SYDNEY INTERMODAL TERMINAL ALLIANCE

## Submissions Report

December 2013

FIGURE 4 – THREATENED FLORA SPECIES TO BE CLEARED FROM THE STUDY AREA (HYDER: 2013)

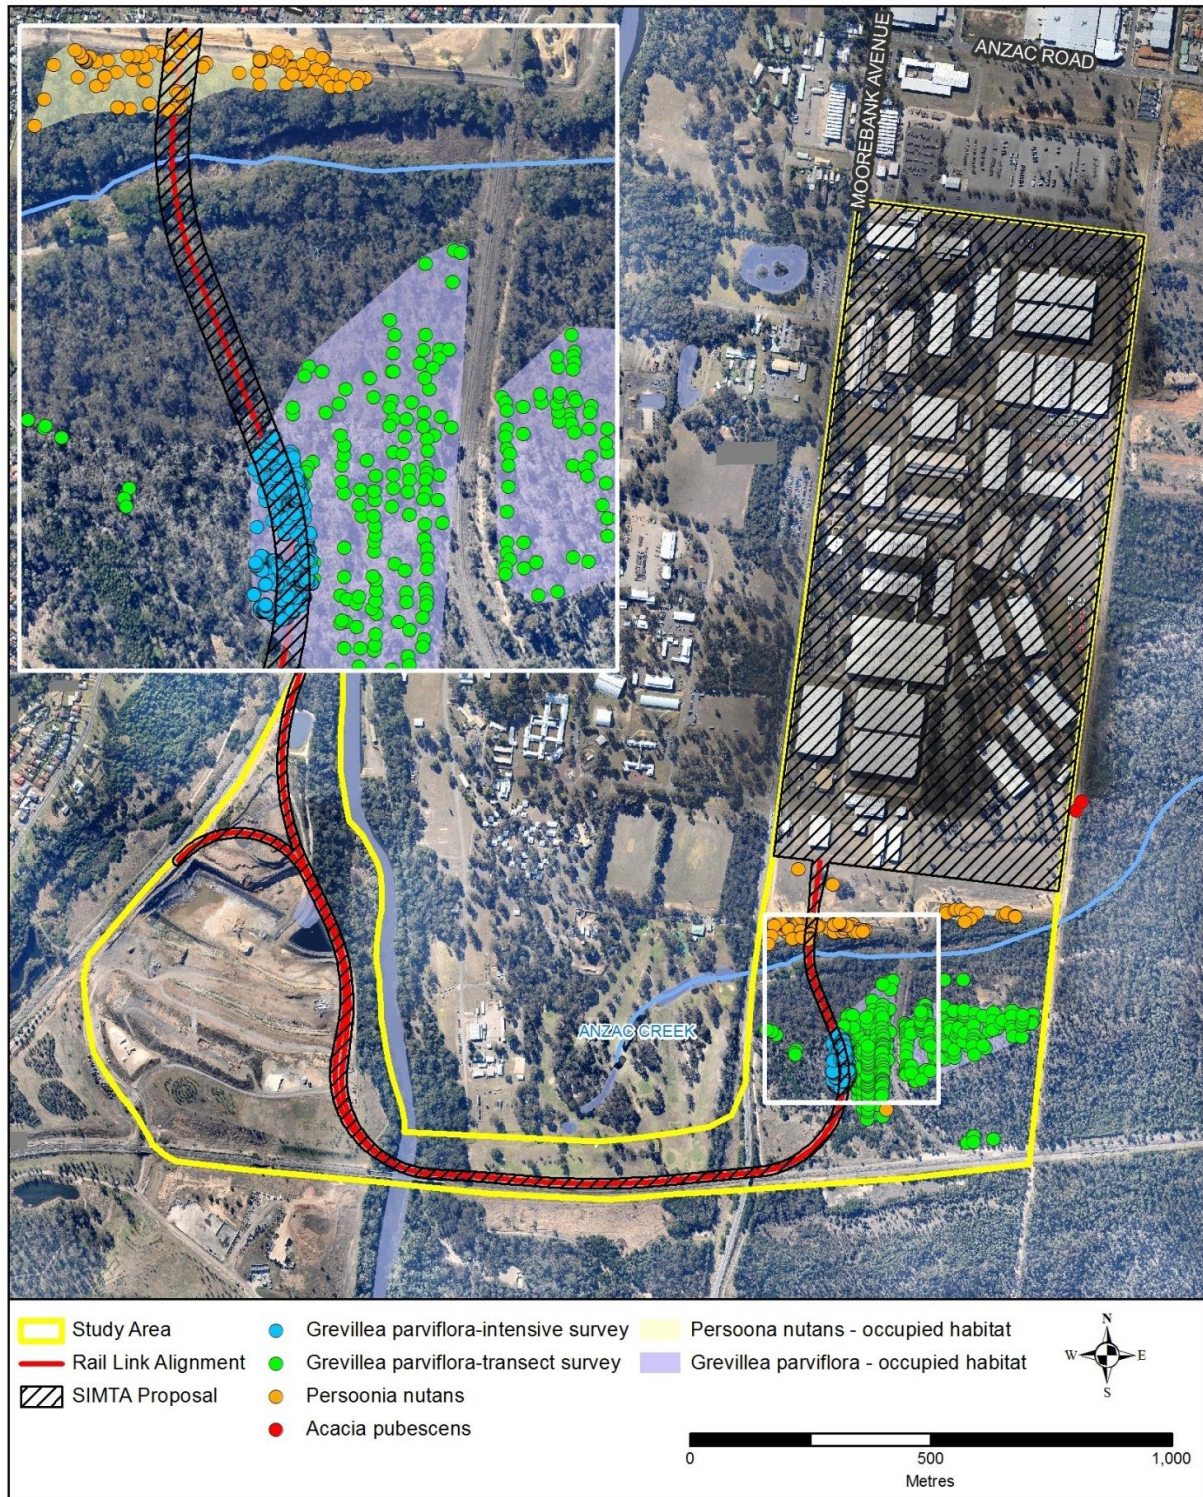
- Groundwater quality and quantity should be considered with regard to potential impacts of the SIMTA proposal on the Castlereagh Swampland Community.
- The Assessment of Significance for the *Grevillea parviflora* subsp *parviflora* should conclude that the proposed works will result in a significant impact.

- The population of the *Grevillea parviflora* subsp *parviflora* is considered significant within the study area. However, the SIMTA proposal is considered unlikely to have a significant impact having regard to the estimated population and the proposed loss of stems. Further, the proposed rail link will not fragment a large area of known habitat from other areas of known or potential habitat. Consideration of offsets will be included within the updated Strategy in consultation with the OEH (and as updated within the Statement of Commitments).

- A map of the potential habitat for threatened species that was used in the calculations in Table 24 of the *Flora and Fauna Assessment* is provided in the following Figure.
